Subject: AP1000 Response to Request for Additional Information (SRP TR03)

Response to Request for Additional Information on SRP Section TR03

RAI Response Number: RAI-TR03-022
Revision: 4

RAI Response Number: RAI-TR03-037
Revision: 2

Figure 3G.4-7X: X Direction FRS for Node 4724 (NI10) or 2078 (NI20) ASB Control Room Side Elevation 116.50′

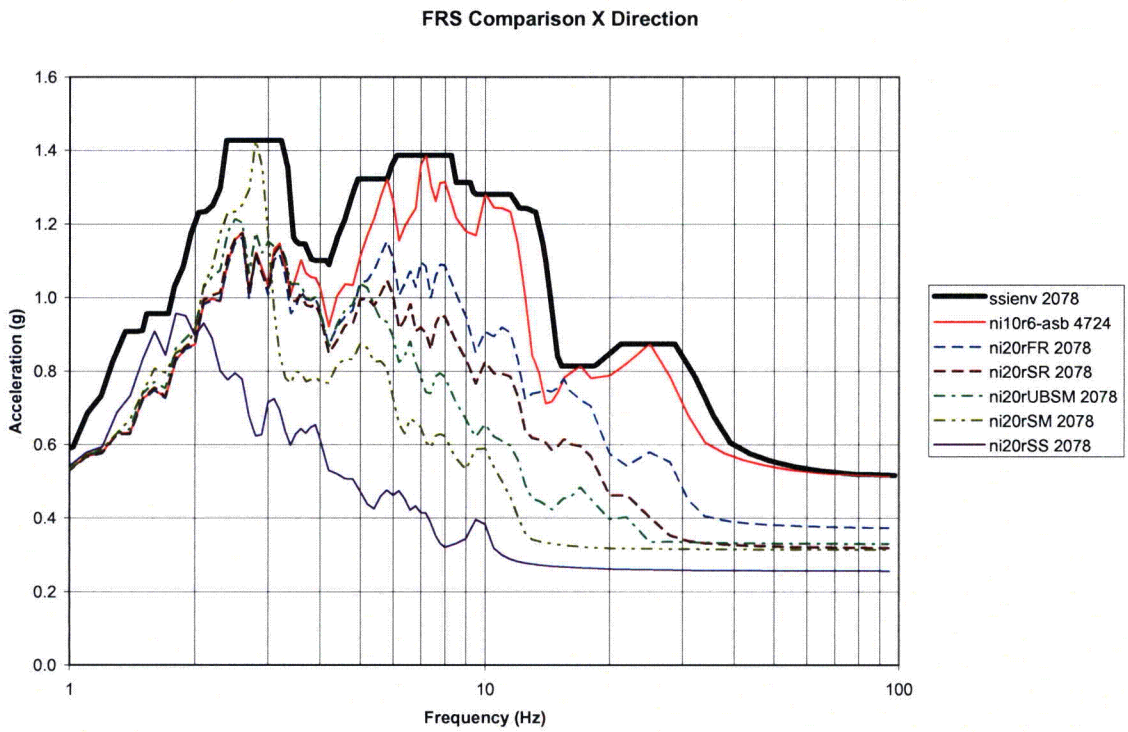
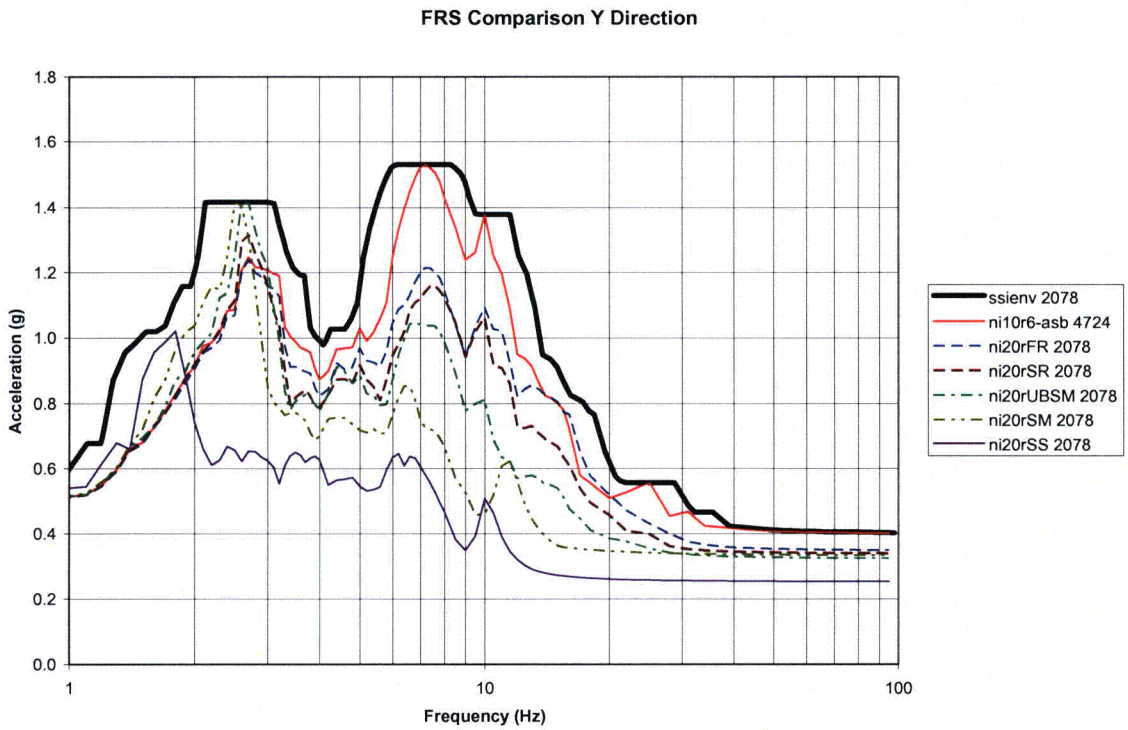
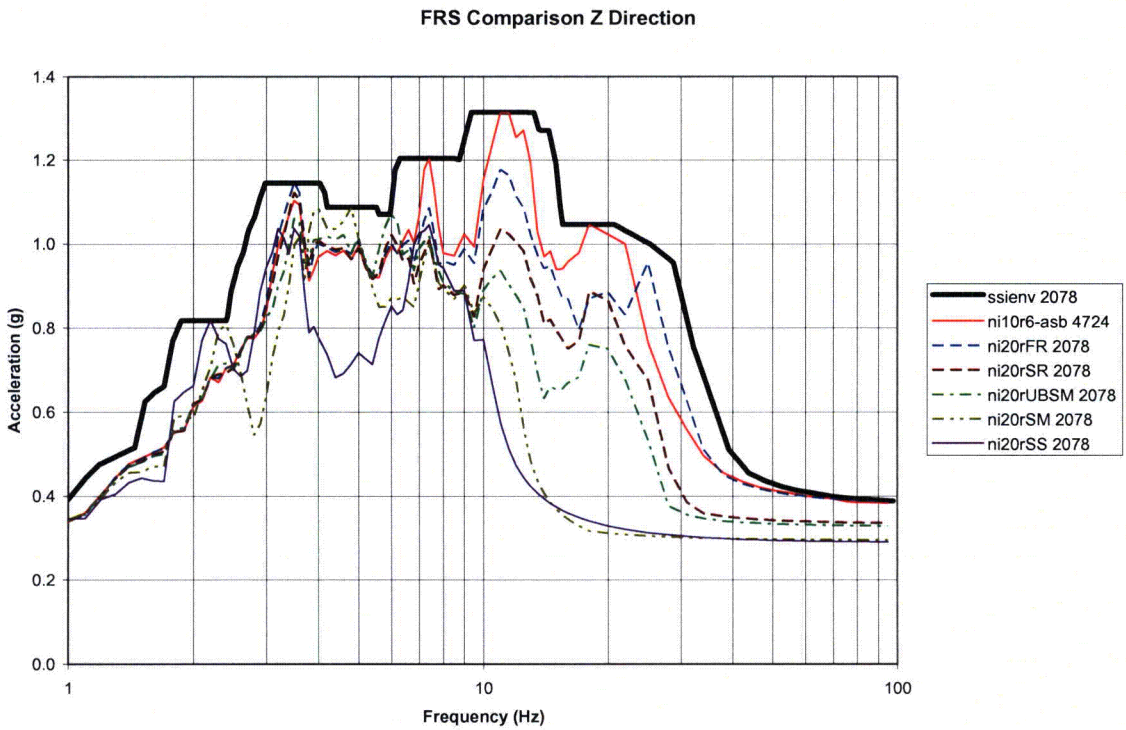
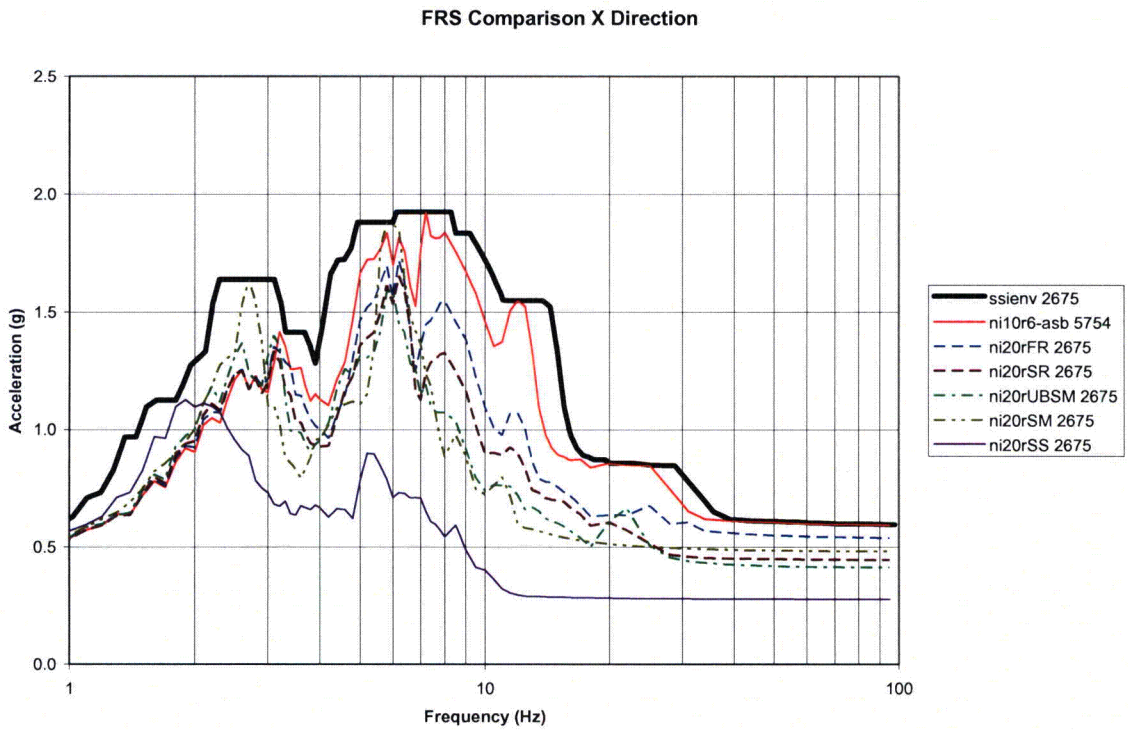
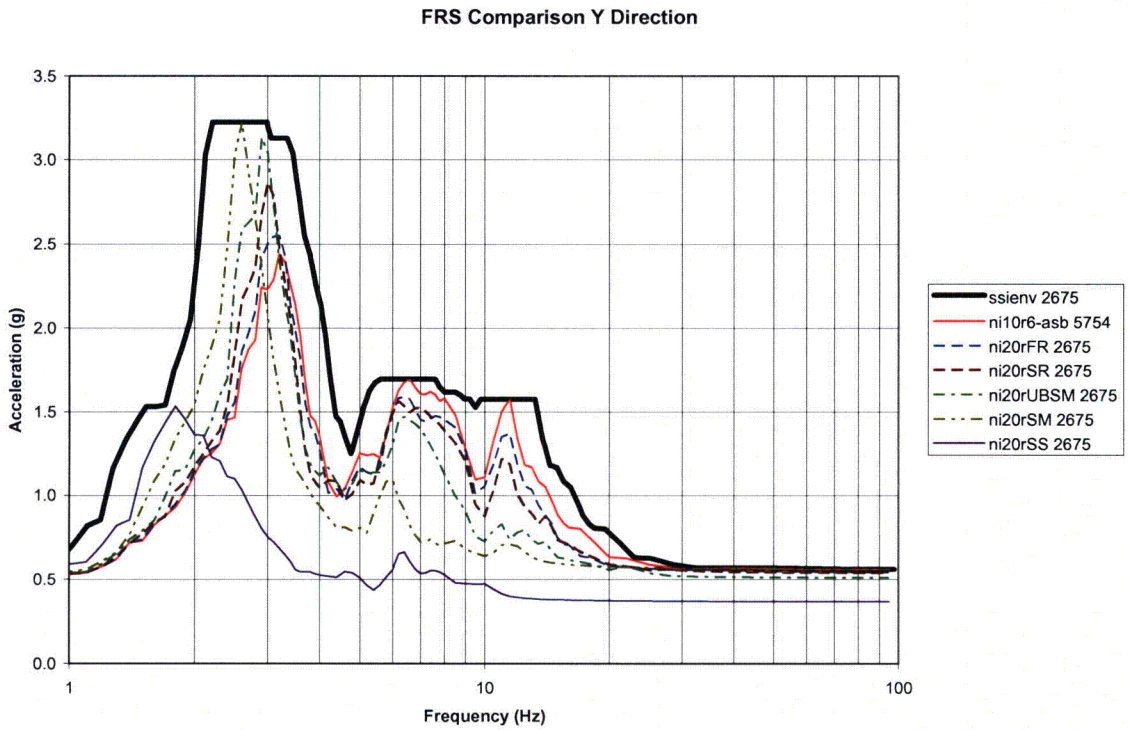
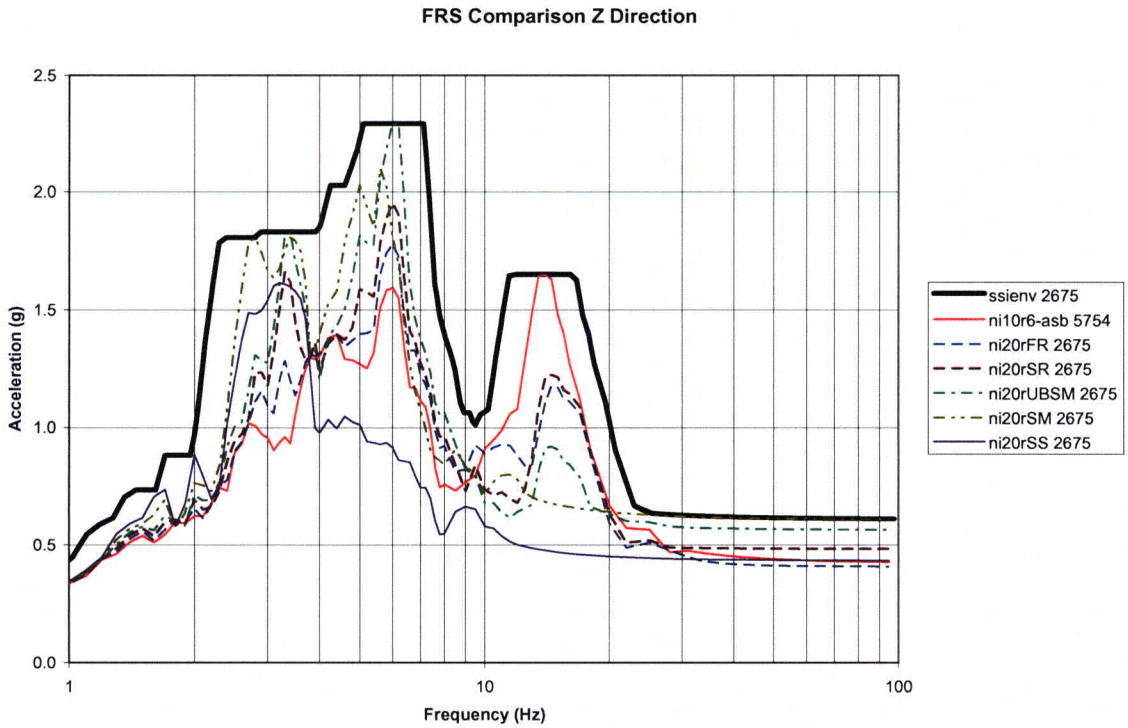
- Appendix E – Remove the deep soil case from Figures 3G.4-5X to 3G.4-10Z as shown below:

The deep soil site is removed from Technical Report (TR-03). If applicable, a deep soil site will be considered within a COL application. The changes to TR-03 are identified in the Technical Report (TR) Revision sections below. In DCD subsection 3G.4.3.3, a sentence is added to recognize that the design seismic response spectrum is conservatively adjusted in the low frequency range.
